Start-up Training Sequence Proposal

December 15, 2005 T10/05-397r1

Harvey Newman
Sr. Staff Engineer

Training Sequence Only Used for G3 Speed Negotiation

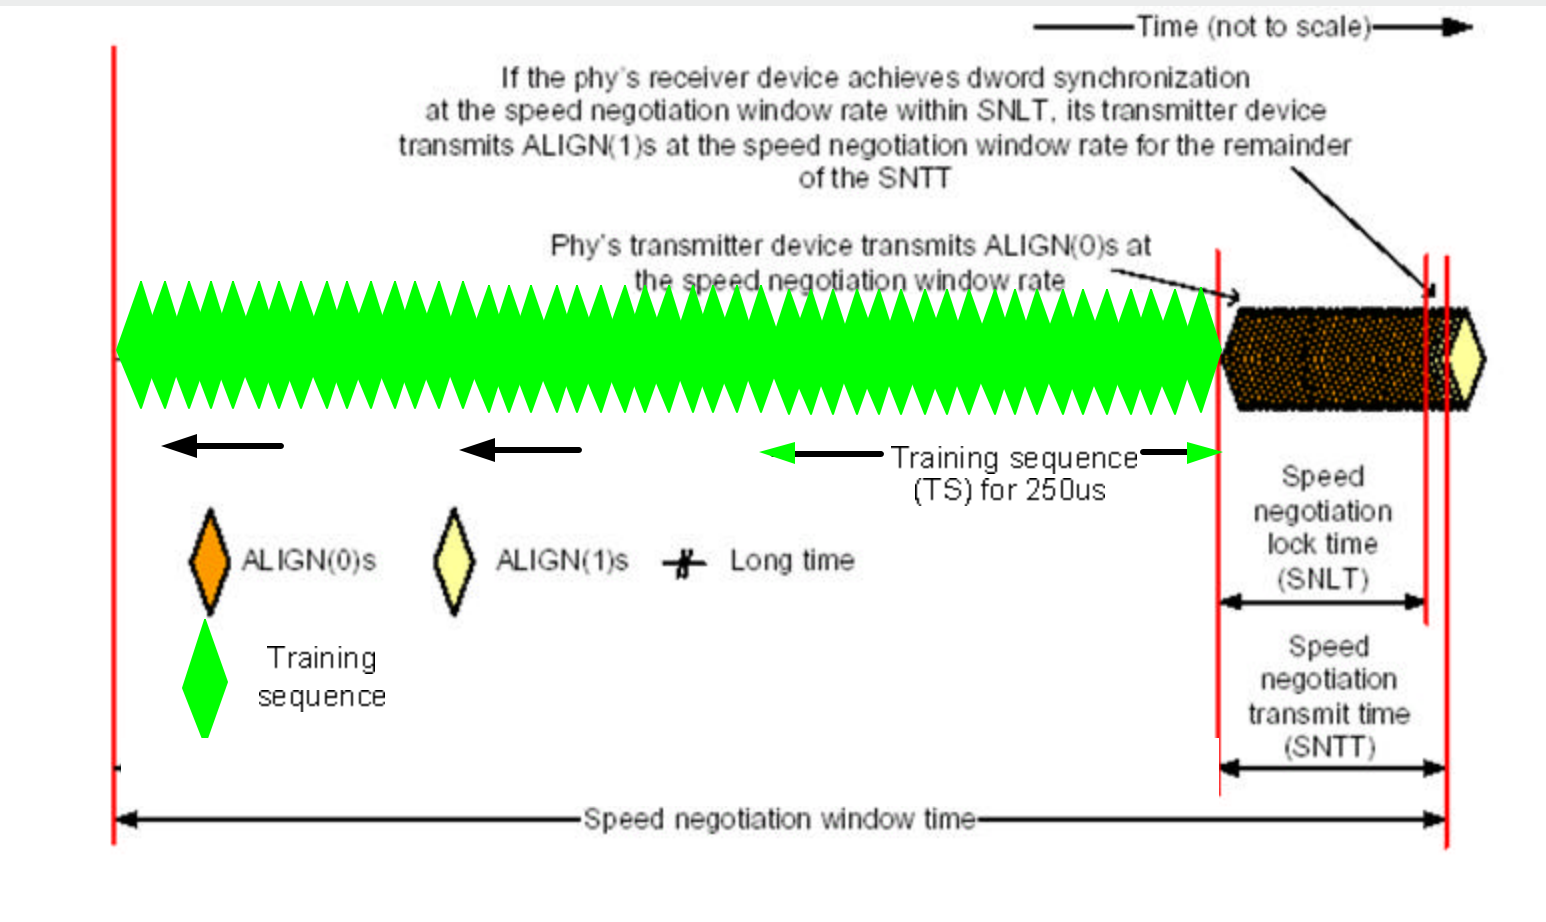
Pattern (in Hex)	Purpose
00 FF 00 FF 00 FF	48 bits - $f/16$ square wave
00 80 00	24 bits - positive impulse with 12 leading and trailing zeros
FF EF FF	24 bits - negative impulse with 12 leading and trailing ones
55 55 55 55 55 55	48 bits - $f/2$ square wave
00 FF 00 FF 00 FF	48 bits - $f/16$ square wave
Scrambled data starting with seed 0h	192 bits - pseudo-random
